Subject: LaSalle County Station Units 1 and 2
Teledyne Open Item and Error/Deviation
Reports for the LaSalle Independent
Design Review, Supplemental Responses
NRC Docket Nos. 50-373 and 50-374

Subject: Supplemental Responses for the
LaSalle Independent Design Review

SUPPLEMENTAL RESPONSE FOR ERROR REPORT 7

Table 3—Computation Sheet for Local Stresses in Spherical Shells (Hollow Attachment)

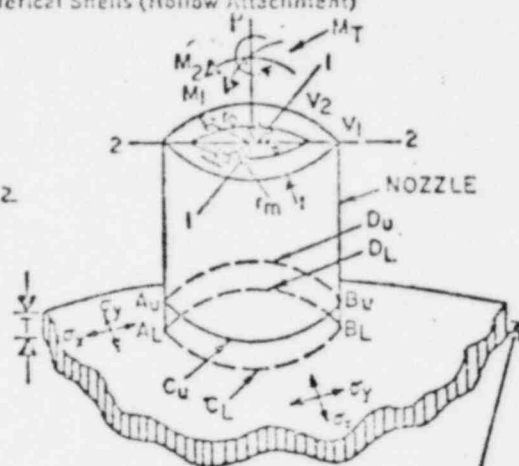
Analysis of Discharge Elbows at Stuffing Box Junction

The junction between the discharge elbow and the stuffing box is not a cylindrical nozzle but an intersection with two radii of curvature. The radius of curvature is in the transverse plane.

To accurately compute the local stresses at this junction under imposed piping loads, a detailed analysis using Bijlaard's stress tables was completed. (See attached sheets) From these calculations the worst combined stresses for the emergency loads are found to be 25763 psi at points A,B, and 19926 psi at points C,D. These stresses are well below the allowable value of $1.8S = 1.8 \times 17,500 = 31,500$ psi for emergency and $1.65S = 1.65 \times 17,500 = 28,875$ psi for upset condition.
